SKEP III Home Office Support Site Visit Report

Consultant	Wahib Medanat Consultant Engineer	Rep No.	12-08062021
Contractor	Derar Saraireh & Sons for Engineering & Contracting	Tender No.	(11/2019/USAID/SKEP/3/S) Schools for a Knowledge Economy Project (SKEP) - Phase (3) Package (1, 2)
Site Name	Al Khansa' Basic Mixed School- Al Balqa	Day/ Date	Tue. 08/06/2021
Duration of Project	450 Calendar Days	Total Project Budget	9,789,417.840 JD

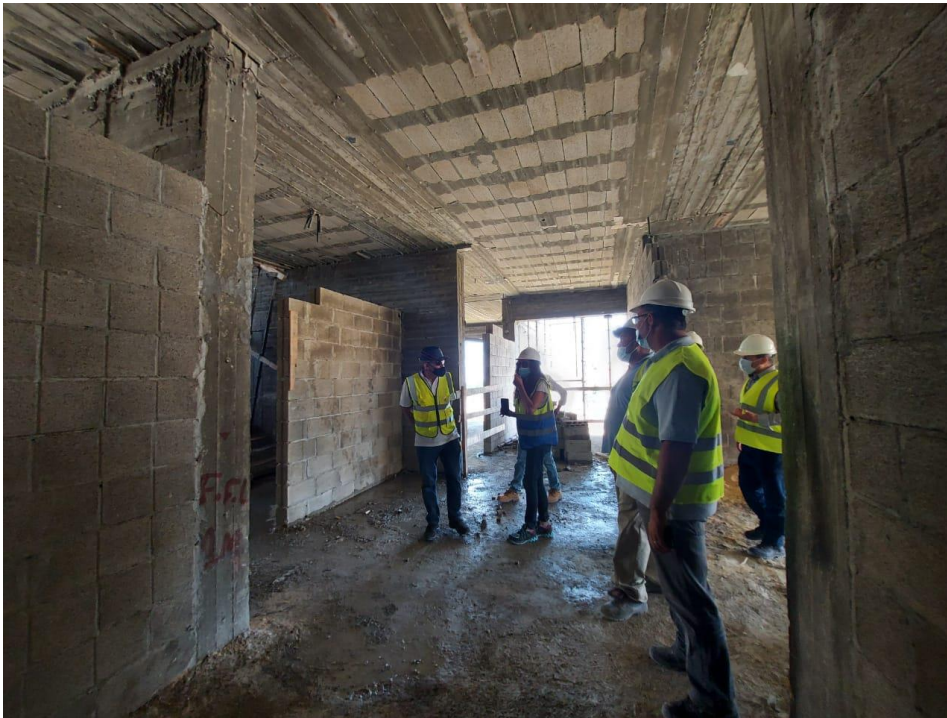
Visual inspection has been conducted at the delivered building stone. The chiseling for number of observed stones is not accepted. The texture should be applied to the whole stone up to edges
